## *Planning Board Staff Report*

**RE:** Boat Dock Extension: 24-000014, 904 Juniper Court, Marco Island, FL. A request to allow for a boat lift canopy on an existing dock to extend an additional 2.6 feet, for a total of a 38.6-foot protrusion from the wet face of the seawall.

**PLAT MAP**

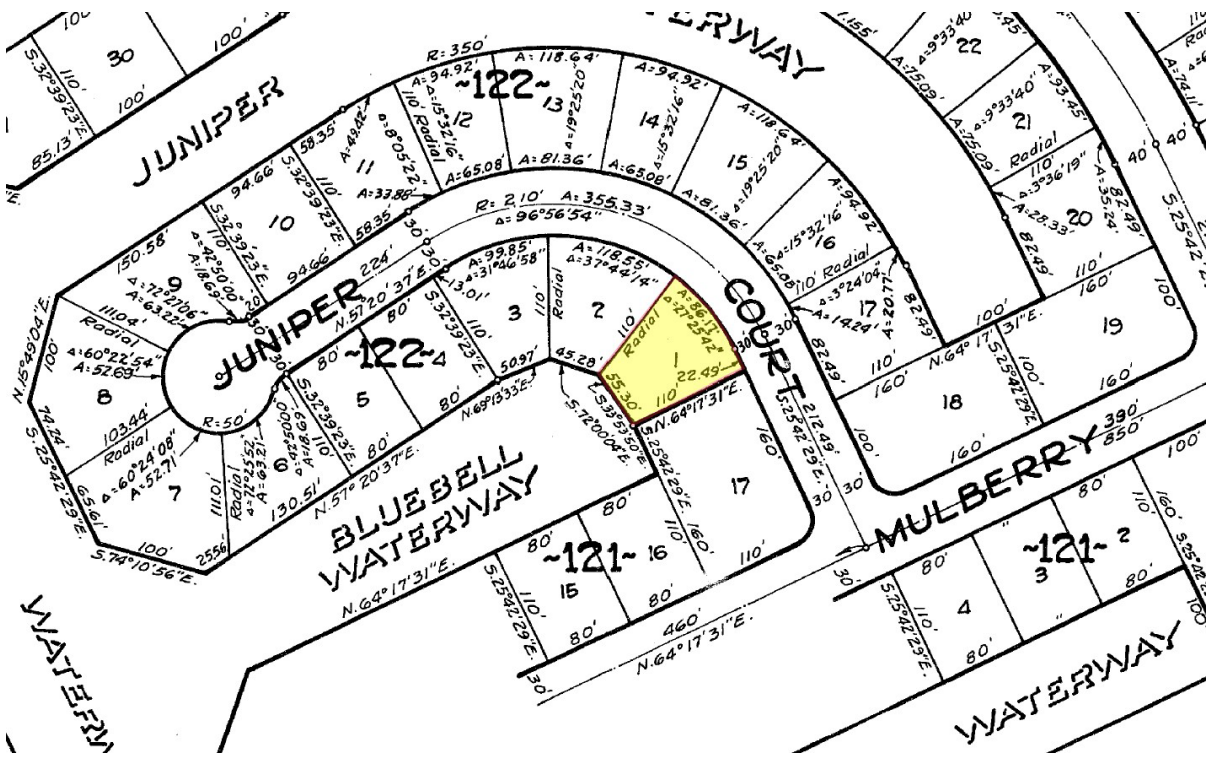
The subdivision plat shows the seawall frontage at this location is slightly over 55 feet, necessitating the current dock and lift layout perpendicular to the seawall.

**SURVEY**

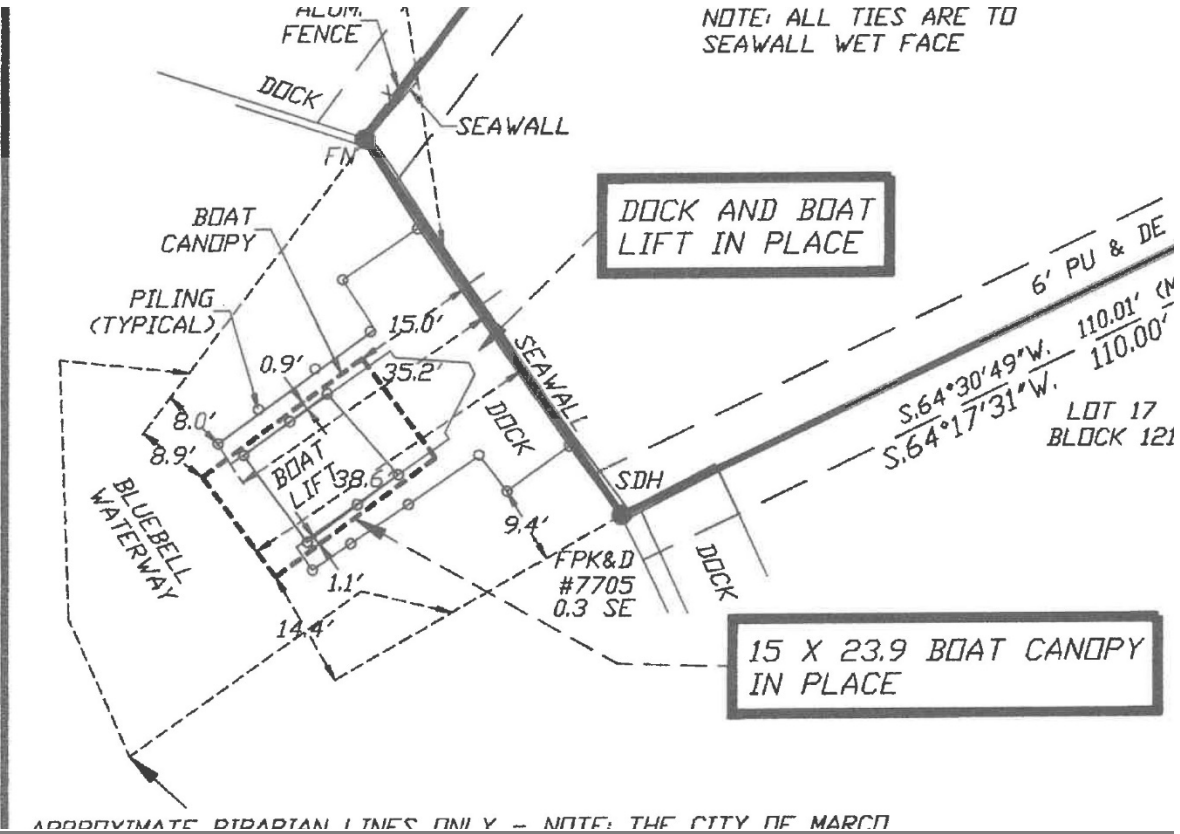
Generally, Staff has little concern with this request. The property owner obtained the necessary permit to install the boat lift canopy and the as-built survey indicated the added protrusion beyond the dock. No additional dock area is being proposed and the canopy is within the dock footprint except for the 2.6' protrusion beyond the dock and the existing authorized 36' protrusion. The property owner has stated that his 24-foot vessel doesn't protrude any further than the canopy. Notification was sent via certified mail to property owners within 300 feet of the site and no comment or inquiries have been received by the date of this staff report.
